DESIGN <i>LE</i>	DRAWN BY <i>LE</i>	DART AEROSPACE LTD HAWKESBURY, ONTARIO, CANADA	
CHECKED <i>PH</i>	APPROVED <i>[Signature]</i>	DRAWING NO. DSI 9348	REV. A SHEET 1 OF 1
DATE 06.08.23		TITLE SKIDTUBE WELD REPAIR	SCALE NTS
A	06.08.23	NEW ISSUE

DART SERVICE INSTRUCTION

TO AMEND MAINTENANCE MANUAL SUPPLEMENTS MMS-D205-634 REV A OR B AND MMS-D204-635 REV A OR B
REF. CANADIAN STC: SH96-88
REF. FAA STC SR00563NY

FIGURE 1. ACCEPTABLE AREA FOR REPAIR
(D205-634-011 SHOWN, D204-635-011 SIMILAR)

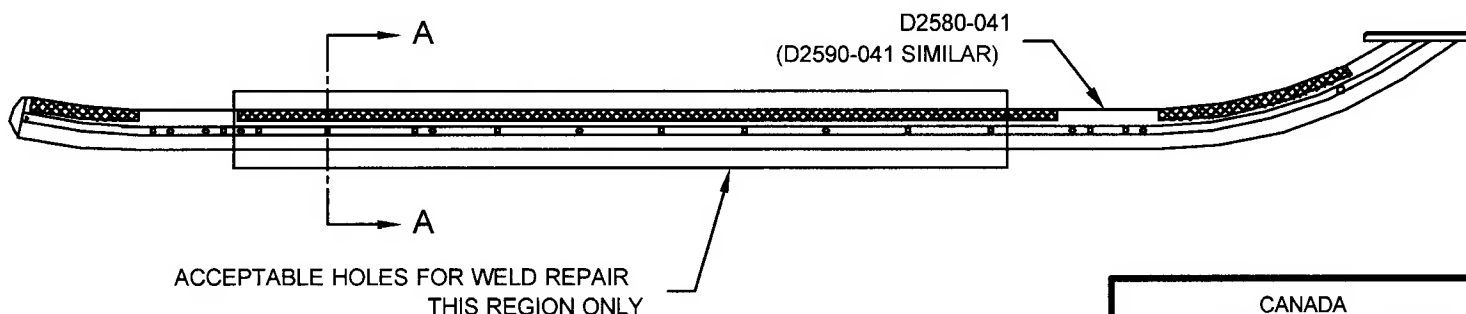
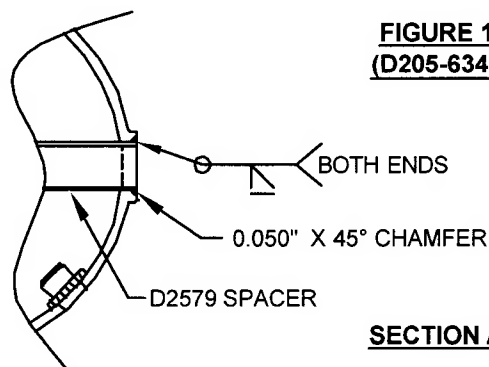
FOR THE D205-634-011 OR D204-635-011 SKIDTUBE INSTALLATION, CRACKS IN THE WELDS AROUND THE HOLES OF THE D2580-041 OR D2590-041 SKIDTUBE ASSEMBLY SHOWN IN FIGURE 1 CAN BE REPAIRED AS FOLLOWS:

- 1) CLEAN AREA OF PAINT, ETC.
- 2) DRILL OUT THE D2579 SPACER USING A $\varnothing 0.508$ " DRILL.
- 3) CHAMFER 0.050" X 45° AROUND THE HOLE ON EACH SIDE OF THE SKIDTUBE. ENSURE THAT ALL REMAINING WELD AROUND THE HOLES IS REMOVED.
- 4) INSERT REPLACEMENT D2579 SPACER.
- 5) T.I.G. WELD CHAMFER PER MIL-STD-2219 / AMS-STD-2219 CLASS 'C' USING 4043 OR 5356 FILLER ROD ON EACH SIDE. DRILL THROUGH SPACER WITH $\varnothing 0.386$ " DRILL (DRILL W) TO REMOVE EXCESS WELD IF NECESSARY.
- 6) BLEND WELDS TO SAME PROFILE AS ORIGINAL PART.
- 7) IF USED FOR GROUND HANDLING, COUNTERBORE BOTH SIDES TO $\varnothing 0.437$ " X 1.00" DEEP AND DEBURR.
- 8) TOUCH UP FINISH IN ACCORDANCE WITH MMS-D205-634 REV A OR B OR MMS-D204-635 REV A OR B.
